**Ship Simulation Transit Scenario Modeling & Ship Pilot Study of the
Maritime Implications for Commercial Ship Transits of the Proposed
Houston Ship Channel Gate Complex**

Prepared for:
Greater Houston Port Bureau

Report Version 7.2, 11/30/2022

Figure 30. Run #4, Second Outbound Ship and Inbound collision near buoy 18

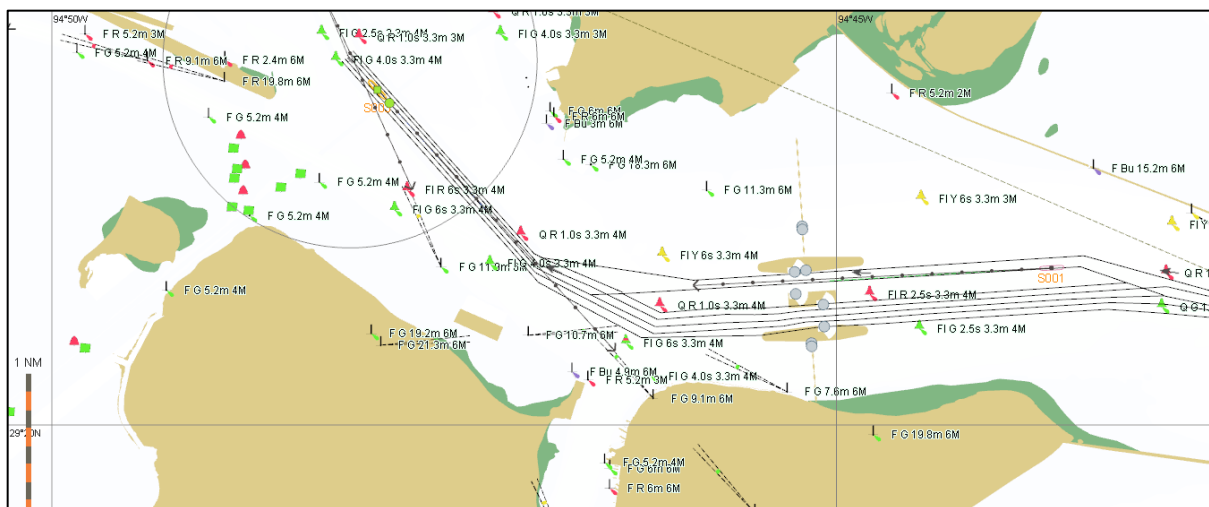
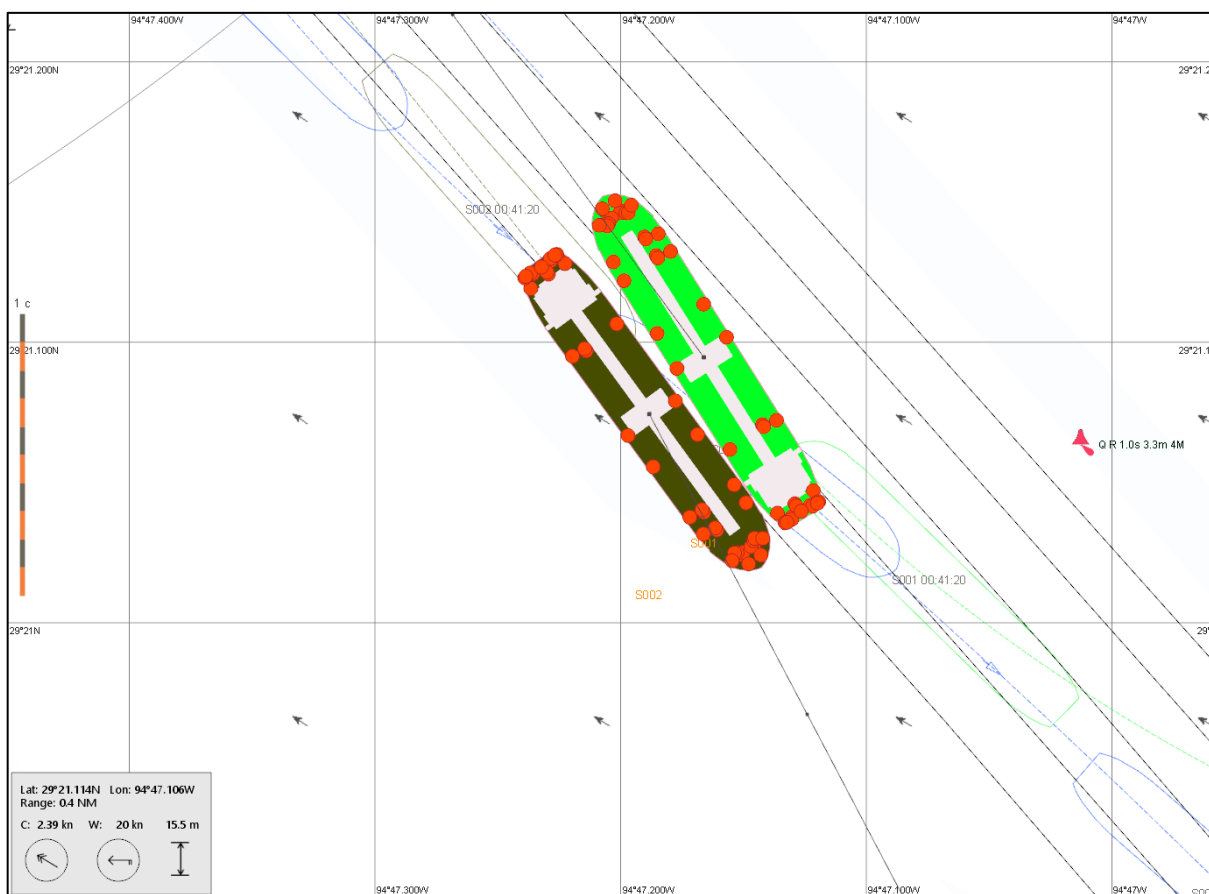
During Run #4, GAR score 3 High Concern, the outbound and inbound ships had a collision near buoy 18. This collision was between two Aframax-class tank vessel models, which was the smallest vessel tested. There was limited visibility due to fog conditions. The inbound ship had completed its transit through the north gate and had met the first outbound ship. When the second outbound ship was aligning with the north gate, it collided with the inbound ship. The pilots stated the collision was due to visibility issues combined with the flood current. They reported it was difficult to make the turn at buoy 18, and thus the outbound ship had the collision. They stated that if they were transiting through the south gate, they would have had more time and space to maneuver. Therefore, two-way commercial ship traffic should not utilize a single gate complex. Instead, a single gate-complex should only utilize one-way commercial ship traffic.

Figure 32. Run #9, Near Collision between Outbound ship and Second Inbound Ship in North Gate, Skin-to-Skin 70'

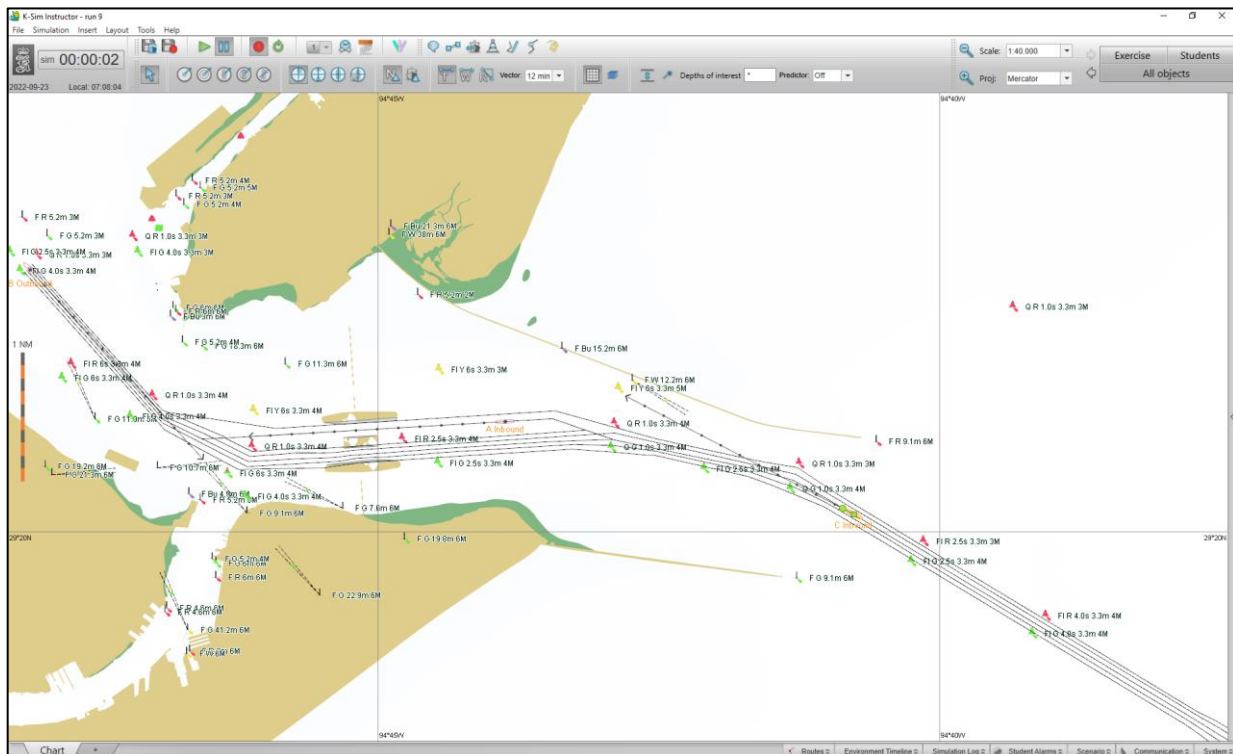
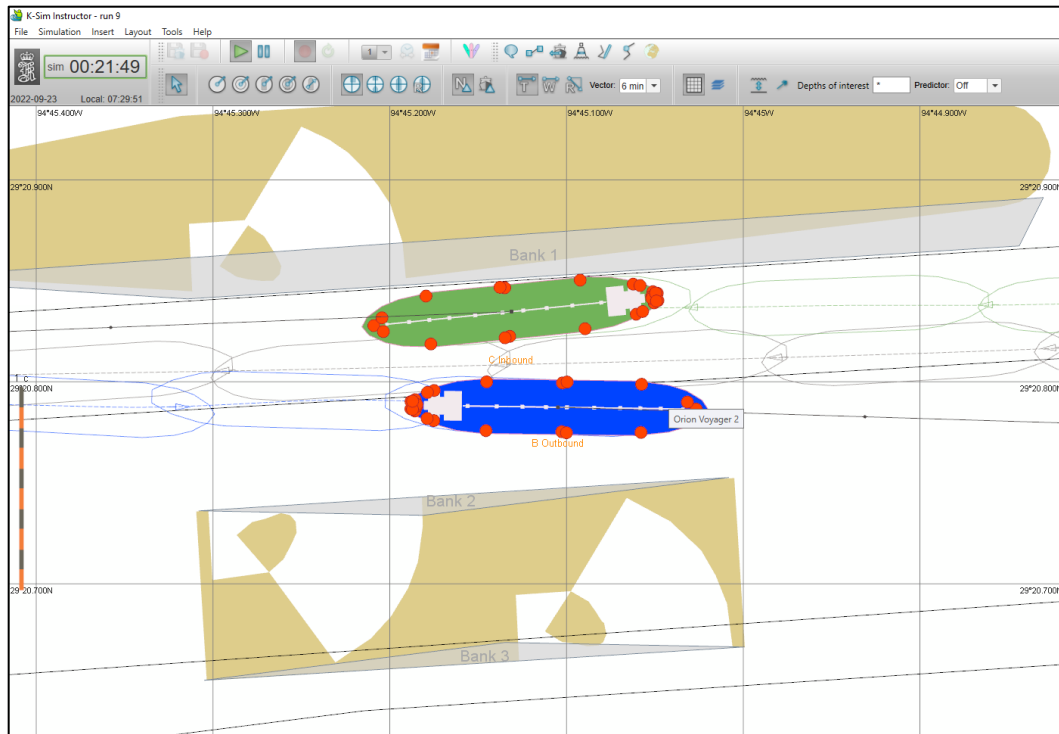
During Run #9, GAR score 3 High Concern, the outbound and second inbound ships had a near collision inside of the north gate. This was with the Suezmax class of tank vessel and in clear daylight conditions. The first inbound ship had completed its transit through the north gate and had met the outbound ship. When the outbound ship was aligning with the north gate on the center line it unexpectedly collided with the second inbound ship inside of the gates. The outbound ship reported that they were not aligned when entering the north gate. Rather, they entered the north gate complex at an angle and off centerline. The flood current made it more difficult to line up properly with the north gate complex. This event was unplanned. The starting position of the outbound ship was near buoys 25/26 and the starting position of the second inbound ship was near buoys 7/8. This is further evidence that two-way commercial ship traffic should not simultaneously use a single gate complex, but instead, utilize a one-way traffic scheme when sharing a single gate.

Figure 35. Run #37, Unsafe Meeting Inside of North Gate with Shearing Force Calculations Inbound Ship (Green) 156 tons, Outbound Ship (Red) 307, Skin-to-Skin 65'

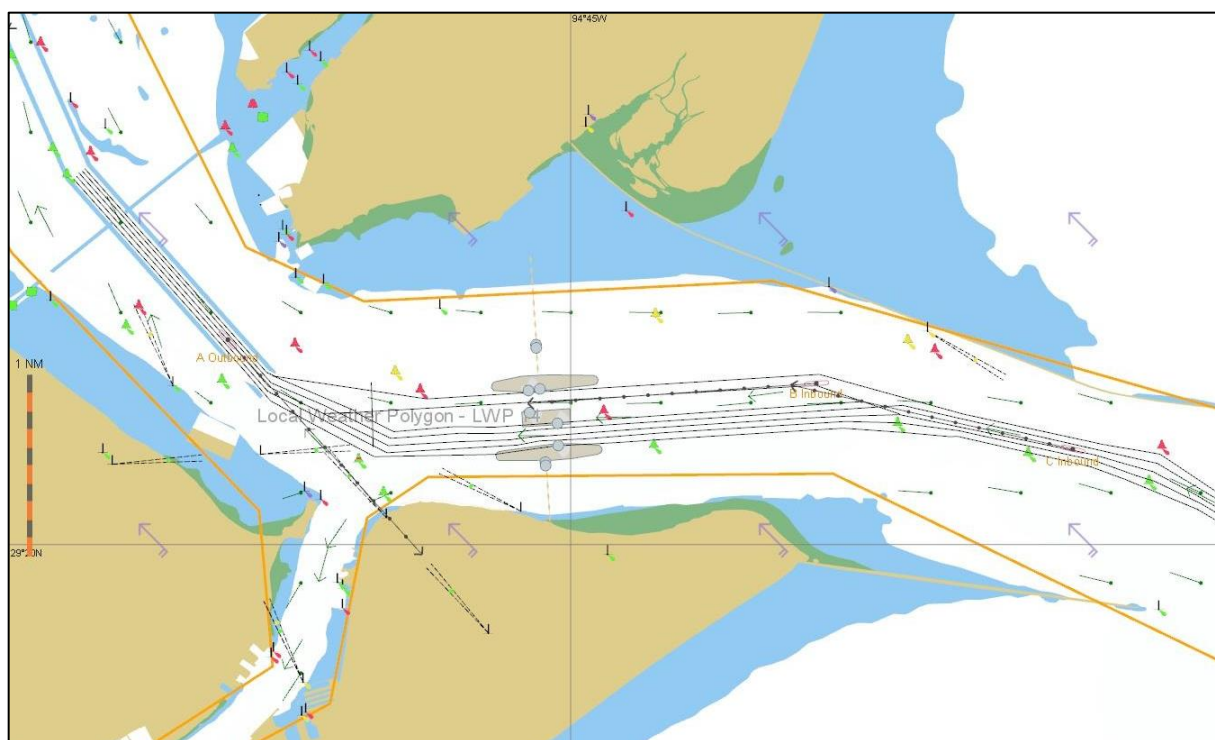
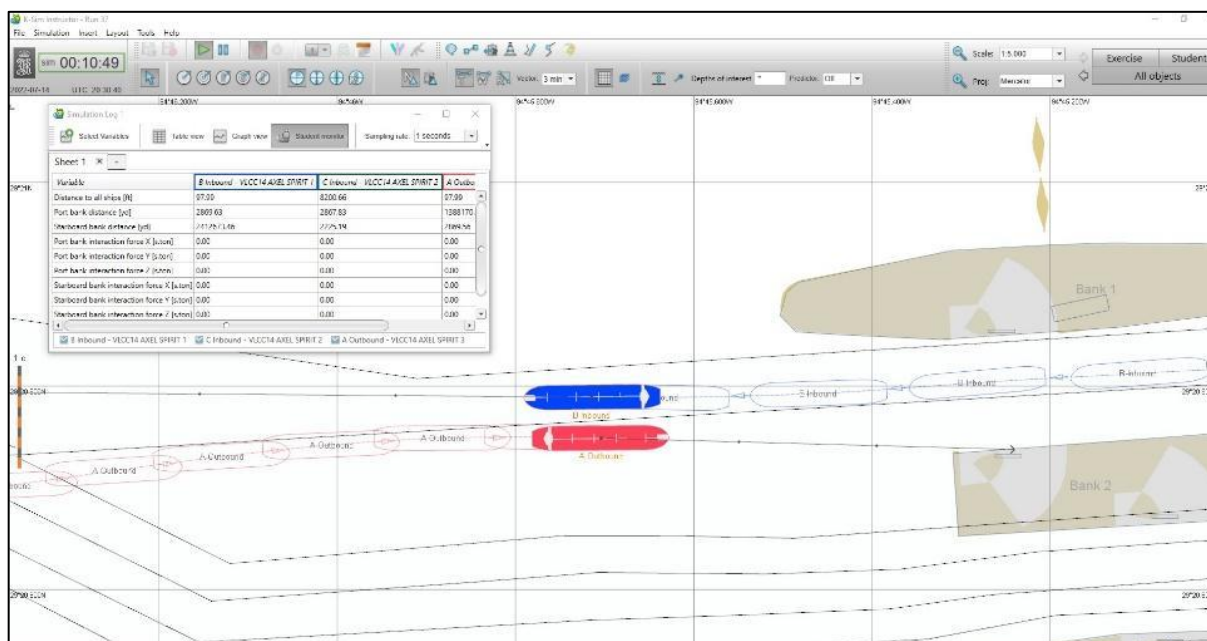
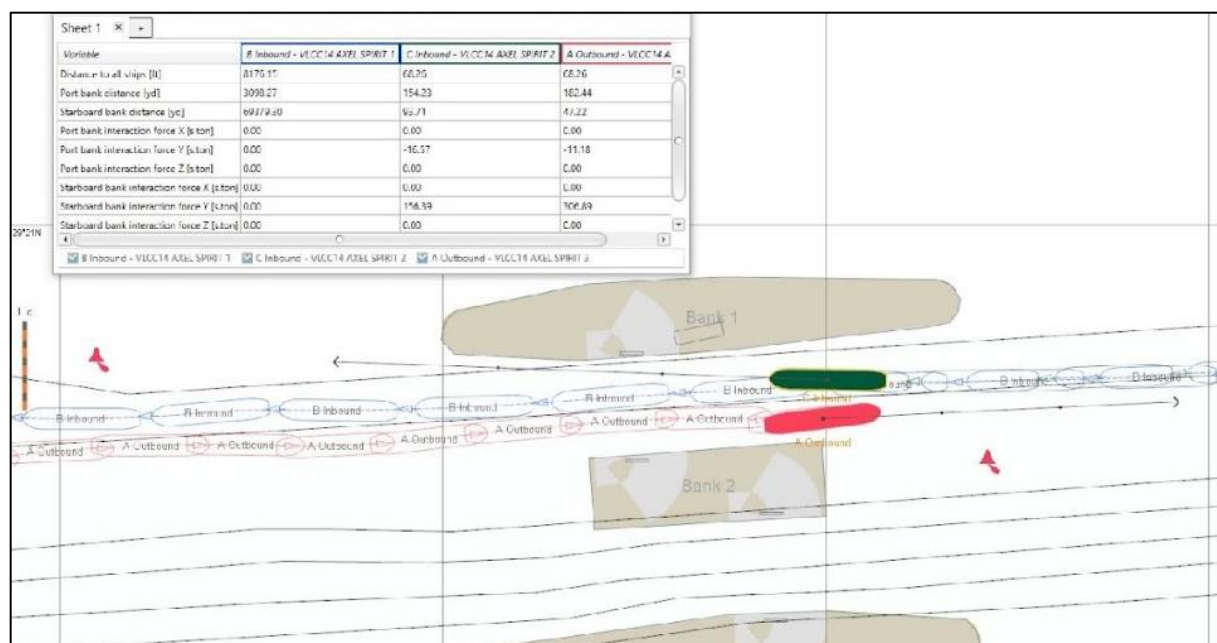
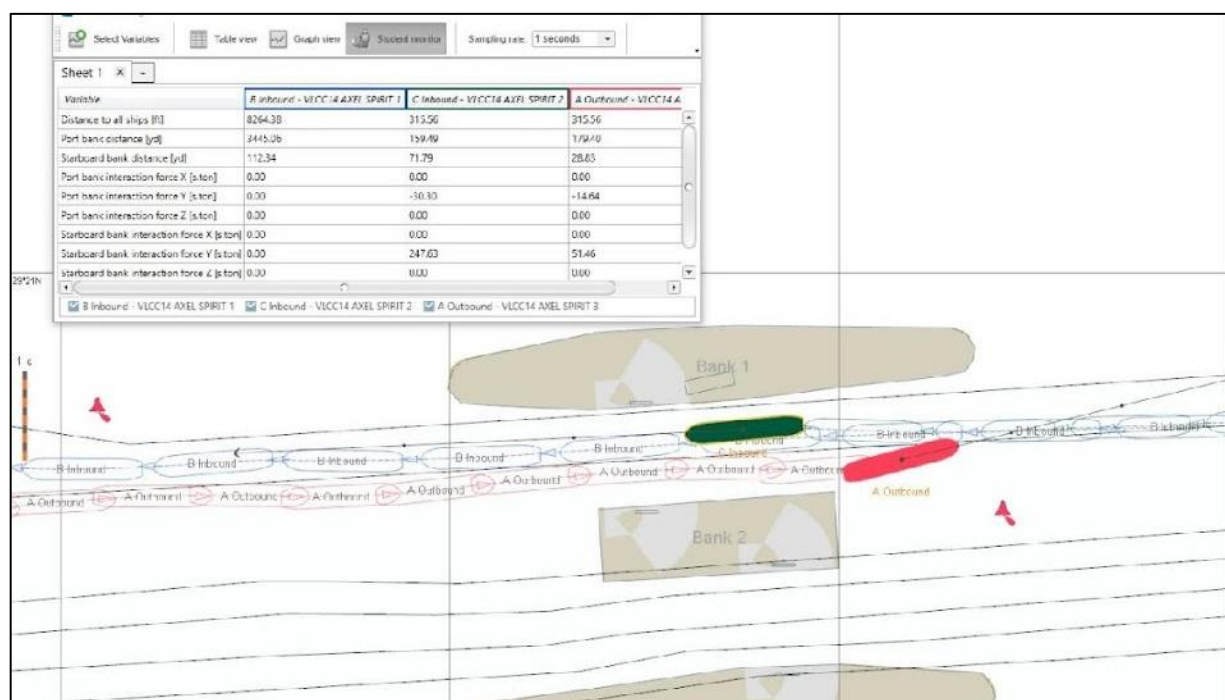
During Run #37, GAR score 3 High Concern, the outbound and first inbound ship got too close on their meeting inside of the north gates as the skin-to-skin distance was 95'. The second inbound ship then had a near collision inside of the north gate with the outbound ship. This led to shearing forces on the ships that caused the outbound ship to momentarily lose steering control and be pushed towards the inbound ship. The ship model was a common Aframax-class tank vessel and in clear daylight conditions. This is further evidence that the islands of the gate complex need to be symmetrical to prevent shearing forces upon the ships. Also, that ships transiting need to utilize both gates. The pilots also commented that they should have bail out areas nearby the gate complex. In this extremis case, the pilots realized they were potentially going to collide in the gates. Instead, they prefer being able to bail out nearby the gate complex.

Figure 38. Run #7, Outbound Vessel Alisson with South Gate Island,

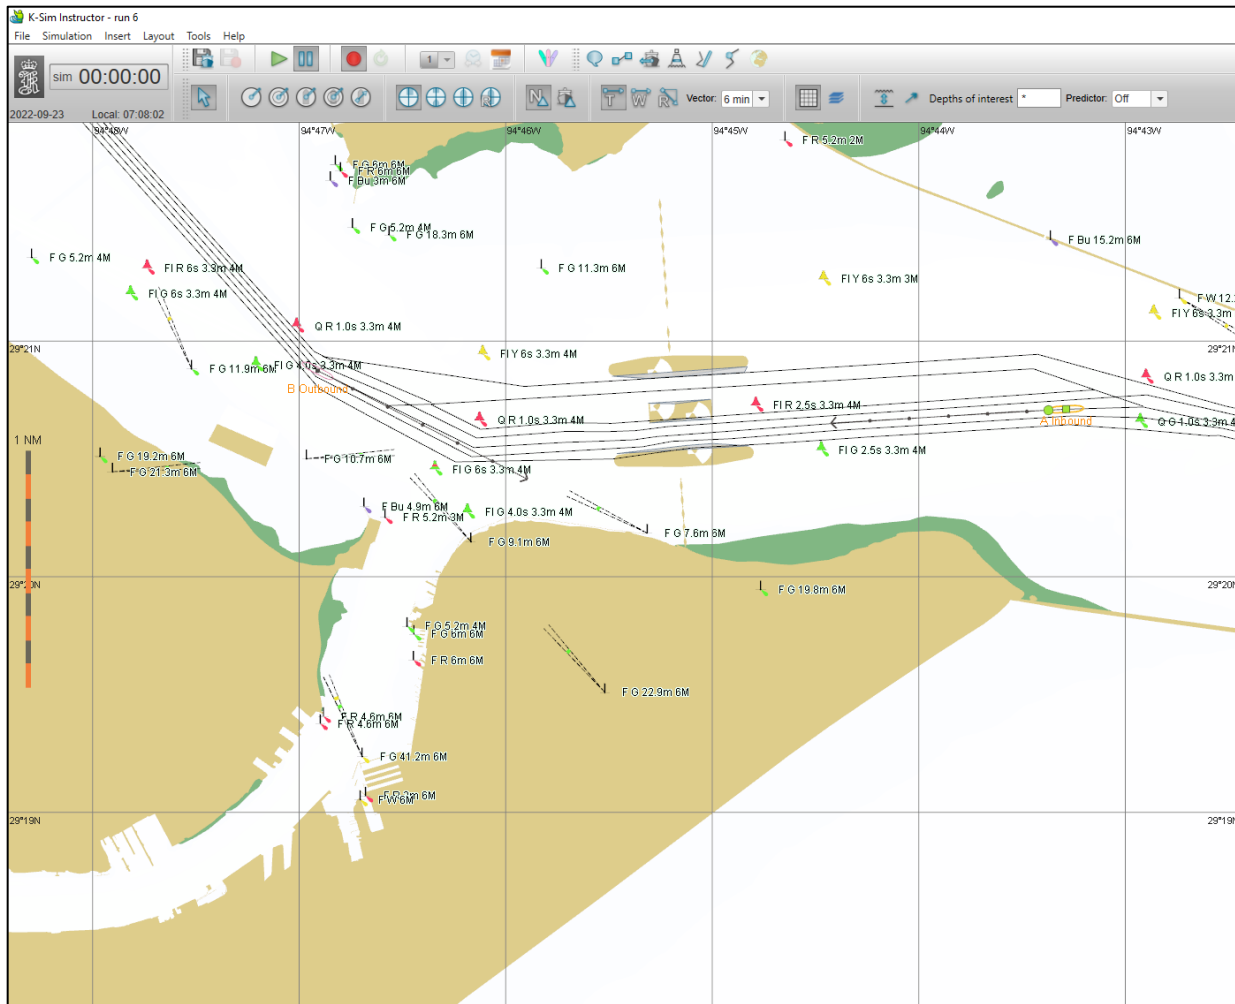
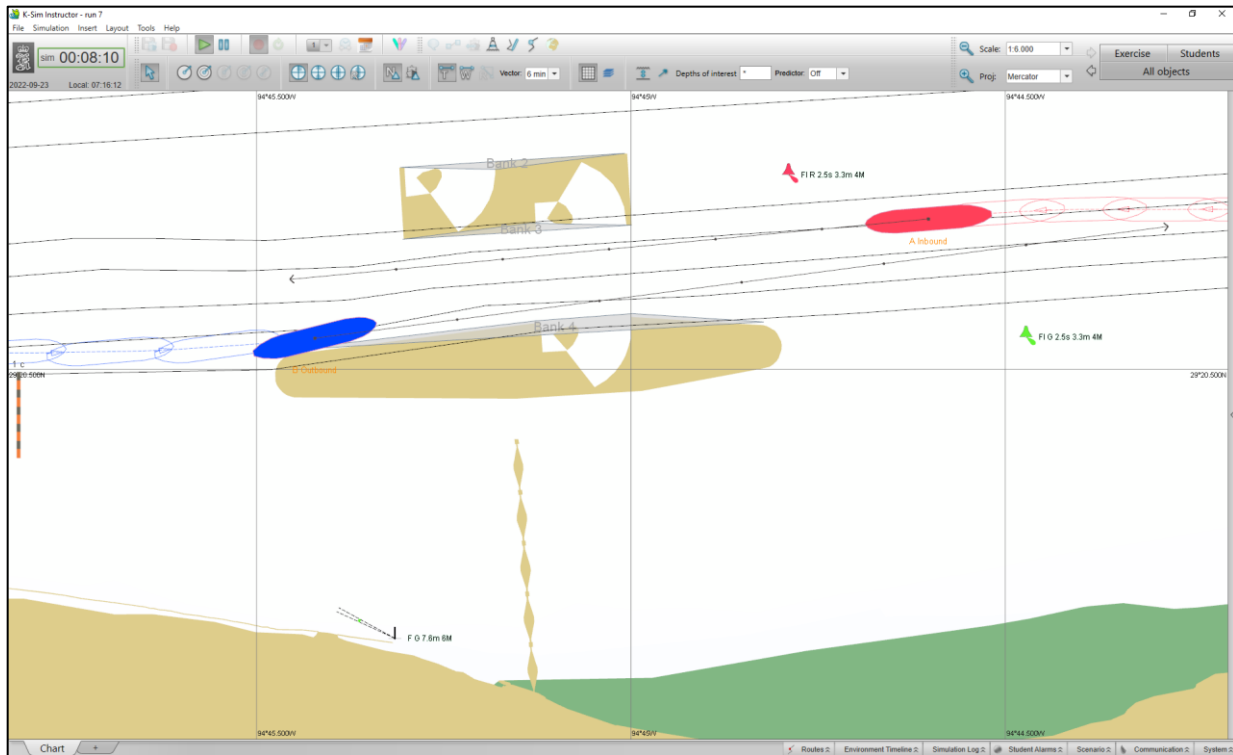
During Run #7, GAR Score 3 High Concern, the pilot was unable to successfully complete the turn outbound at buoys 18 and 16 from HSC in a 2.5 knot ebb current. This occurred using an Aframax-class tanker, which was the smallest test vessel. This simulation demonstrates that the distance from buoy #18 to the gate complex is foreshortened and needs to be extended. The ebb current (2.5 knots) further extends the turn requirements for vessels. Therefore, the gate complex is sited too far to the west in the Bolivar Roads, it needs to be sited further east and away from the turn at buoys 18 and 16 in the HSC.
